**ENSTROM HELICOPTER CORPORATION**

## SERVICE DIRECTIVE BULLETIN

SERVICE NOTE NO. 0005

SUBJECT: Belt Drive Support Strut P/N 28-13227

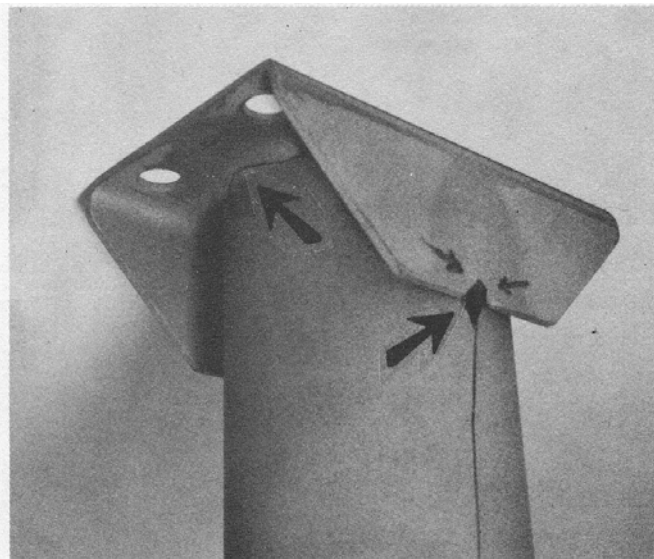
A few instances have been reported of cracks developing in the upper end of the belt drive support strut, Part No. 28-13227. The cracks have developed in the welded joint in the mounting bracket and outer sleeve assembly, Part No. 28-13225. The figure below shows the locations of where the cracks occur.

The cracks, in most probability, will occur on the aft side of the mounting bracket; however, a visual inspection must include both the forward and aft sides of the bracket.

A static visual inspection with the belt tightening mechanism fully engaged is mandatory every ten (10) flight hours. This inspection interval is to be completed until the belt drive support strut is replaced. The replacement strut will include a redesigned mounting bracket.

The replacement of the strut must be done at the earliest convenient time to the customer or within one hundred (100) flight hours from the time of this service note. The replacement should be coordinated with the Service Department of the Enstrom Corporation. With this service note, the Service Department will include complete instructions and procedures to replace the strut.
